**Replacing Pin on Power Distributor if the Power Distributor is Responsible for the Fault (41/14)**

Vehicle Type: **All 911 Carrera models (997)**  
**All Boxster/Cayman models (987)**

Model Year: **As of 2005 up to 2012**

*Installation position of power distributor*

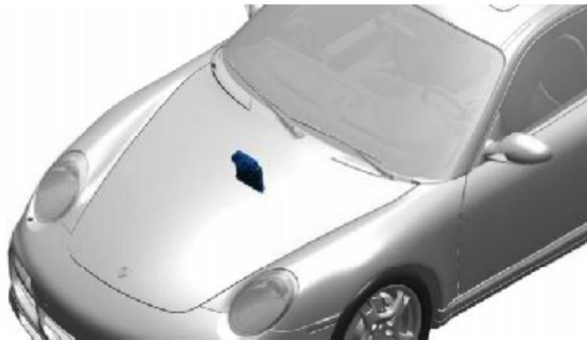
Concerns: **Power distributor** (⇒ *Installation position of power distributor*)

*Item 1 is old style*

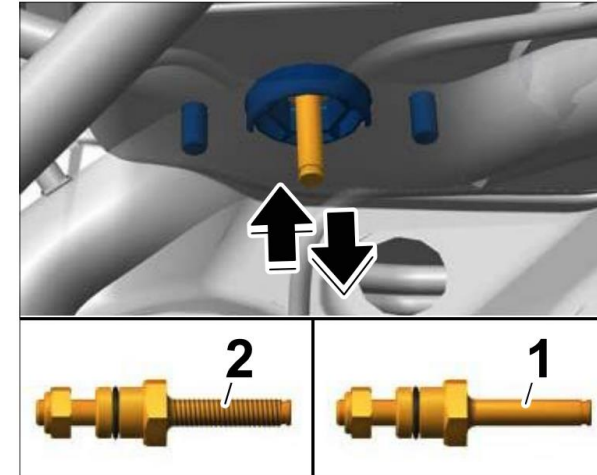
Information: **In the event of complaints relating to the overall power supply on the vehicle and if a "corroded pin in the power distributor" is determined as the cause of the problem, the pin (⇒ *Item 1 is old style*) must be replaced.**

Complaints can include various malfunctions in the vehicle electrics (fault in PCM, failure of power windows or similar problems) or various error messages displayed in the instrument cluster.

Action Required: Replace the pin with a **new, modified pin (item 2)**, see Workshop Manual ⇒ *Workshop Manual '978955 Replacing pins on the power distributor with screw bolts'*.

Parts Info: **997.612.908.00 – NEW** – ⇒ Repair kit containing: B+ line – pin with O-ring (sealing ring) – shrink-fit hose and mounting parts.
